# Analysis of "The impact of remote powering (PoE) on Balanced Twisted Pair Cables.

A white paper by Excel Networking

Results with CAT5e UTP (see page 2) Open air **PAGE 2**

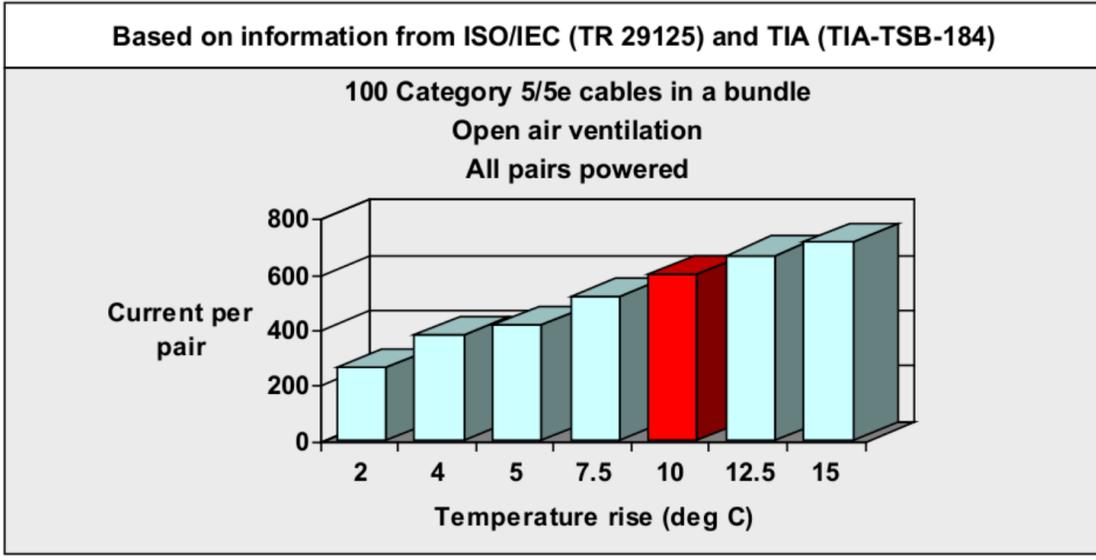
The temperature increase at "60W" is 25.5C for 37 cables in an open air bundle. How do we reconcile this result with ISO/IEC TR 29125 and TIA-TSB-184 ?

60W UPoE is a 4-pair proprietary method which has a worst-case conductor current of 300mA with all 8 conductors powered. This matches with the 600mA current per pair in the Figure above. According to TR29125 a 10C rise is expected from a 100 cable bundle. This is a significant difference with 25.5C for 37 cables/bundle - where does the difference come from ?

**We learned from the exchange that the power levels stated in the paper, 34.2W, 60W and 100W, do NOT refer to the output power of a PSE, but rather the amount of power dissipated in the test cable bundle.**

Results with CAT5e UTP (see page 2) Open air **PAGE 2**

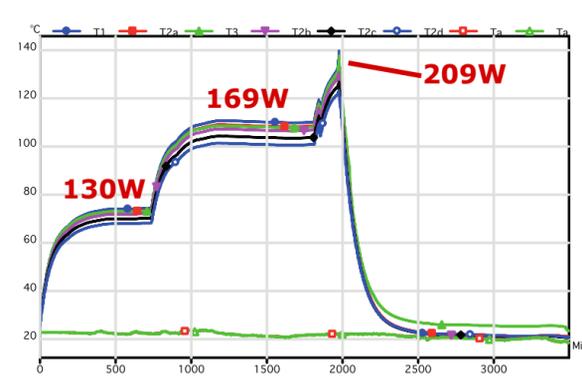
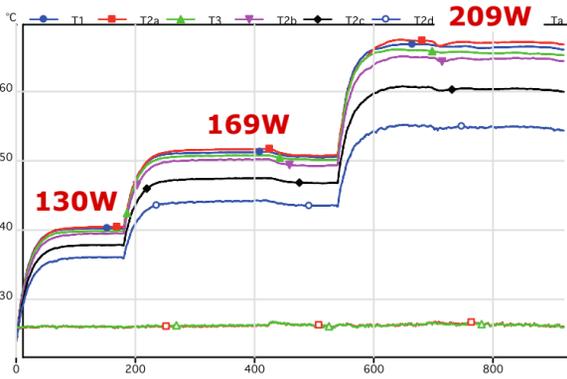
Above are the temperature graphs for CAT5e cable (see details on page 2 and 3), annotated with the "PoE Equivalent" source powers.

What we learn from this is that at current levels significantly higher than what the IEEE P802.3bt task force is considering, this 37 cable bundle, with all conductors powered, reaches 40 degree C in open air and reaches 74 degree C when isolated with 28mm x 25mm foam isolation.
